City of Detroit  
Inter-Departmental Communication

**RE:** Petition No. 1580  
Request to Convert to Easement The East/West And North/South Alleys In The Block Bound By Bellevue, Charlevoix, Concord, And East Vernor Highway

**NOTICE OF PROPOSED CHANGE IN PROPERTY**

REQUEST TO CONVERT TO EASEMENT  
 THE EAST/WEST AND NORTH/SOUTH  
 PUBLIC ALLEY VARIOUS WIDTHS  
 IN THE BLOCK BOUND BY  
 BELLEVUE, CHARLEVOIX, CONCORD  
 AND E. VERNOR HWY.

CITY OF DETROIT CITY ENGINEERING DEPARTMENT SURVEY BUREAU	
JOB NO.	01-01
DRWG. NO.	X 1580

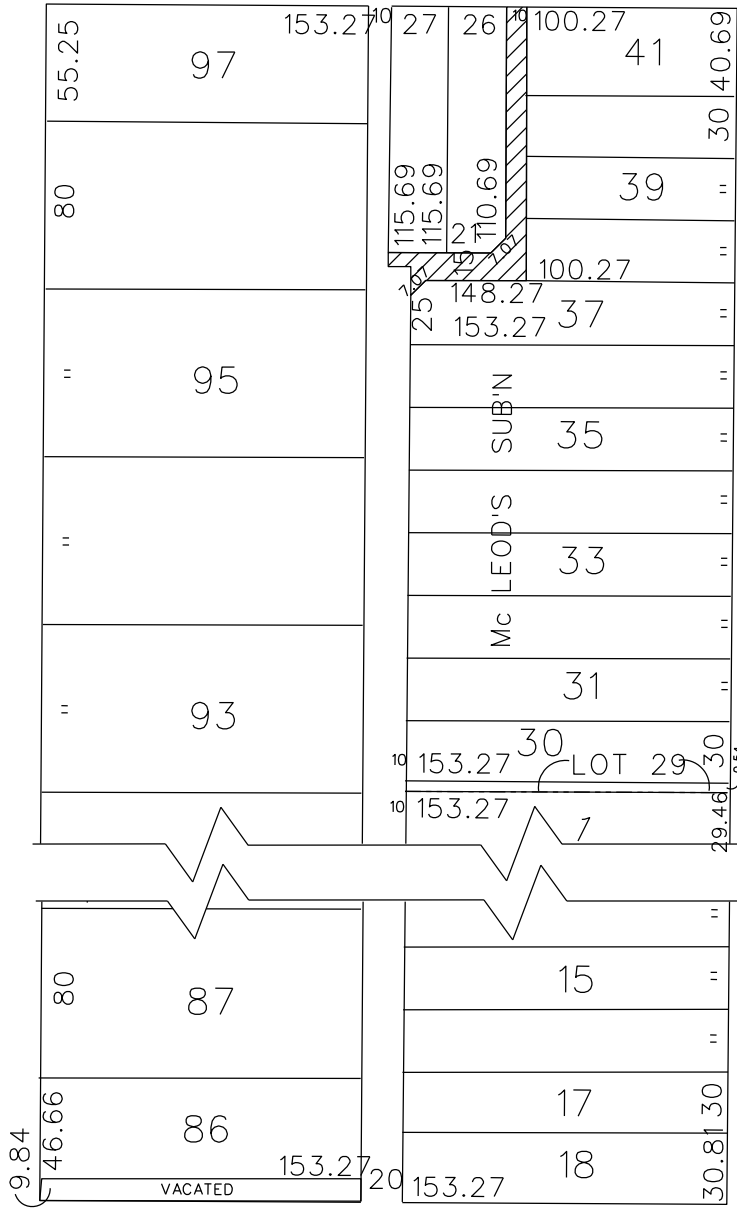
- Our records indicate that there is a sewer in the alley. DWSD has no objection to the requested conversion to easement provided that the attached Provisions for Conversion to Easement are strictly followed.

1. An easement, the full width of the existing right of way, is reserved for the Detroit Water and Sewerage Department for the purpose of installing, maintaining, repairing, removing, or replacing any sewers, water mains, fire hydrants and appurtenances, with the right of ingress and egress at any time to, and over said easement for the purpose above set forth.

2. Said owners of the adjoining property, for themselves, their heirs and assigns, agree that no building or structure of any nature whatsoever, including fences, porches, patios, balconies, etc., shall be built upon or over said easement, or that no grade changes or storage of materials shall be made within said easement without prior written approval and agreement with the Detroit Water and Sewerage Department.
